Access Compliance Report Public Rights-of-Way (Curb Ramps)

Main Street: PEMBERTON_RD		Cross Street: PEMBERTON_RD		Location:	SE
ADA ID: RPRK220221193614	Ramp Type: Type 4 - Parallel	Initial Pass/Fail: Fail	Overall Compliance: No	Severity Score:	2
Codes/Mitigation Info/Possible Solution			Field Measurements/Component Compliance

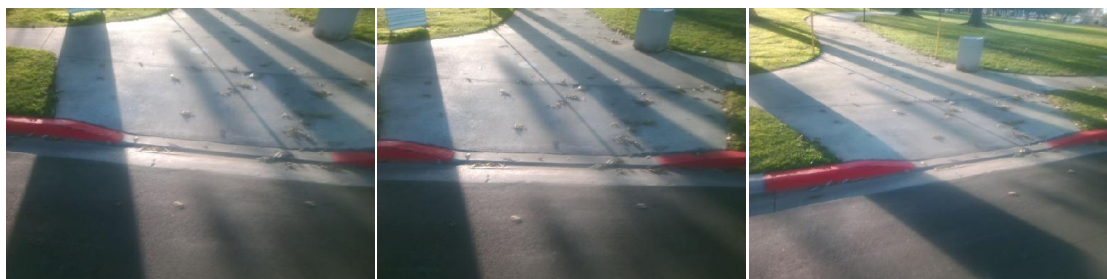
Compliance	Description	Data	Compliance	Description	Data
N/A	Ramp Length LT (in)	84	N/A	Ramp Length RT (in)	95
Yes	Ramp Width LT (in)	77	Yes	Ramp Width RT (in)	77
Yes	Ramp Run Slope LT (%)	3	Yes	Ramp Run Slope RT (%)	4.1
No	Ramp Cross Slope LT (%)	3.5	No	Ramp Cross Slope RT (%)	2.4
N/A	Landing Present	N/A	N/A	DWS Provided	N/A
N/A	Landing Length (in)	N/A	N/A	DWS Contrast	N/A
N/A	Landing Width (in)	N/A	N/A	DWS Length (in)	N/A
N/A	Landing Run Slope (%)	N/A	N/A	DWS Full Width	N/A
N/A	Landing Cross Slope (%)	N/A		DWS Offset Type	N/A
N/A	Landing Movement Obstructed?	N/A	N/A	DWS Offset Left (in)	N/A
	Landing Movement Type	N/A	N/A	DWS Offset Right (in)	N/A
N/A	Landing Shared	N/A			
N/A	Clear Space	N/A			
N/A	Clear Space To Crosswalk (in)	N/A			
N/A	Marked Crosswalk 1	No	N/A	Marked Crosswalk 2	N/A
	Crossing 1 Direction	E		Crossing 2 Direction	N/A
	Marked Crosswalk 1 Width (in)	N/A		Marked Crosswalk 2 Width (in)	N/A

Remove & Replace Entire Ramp.
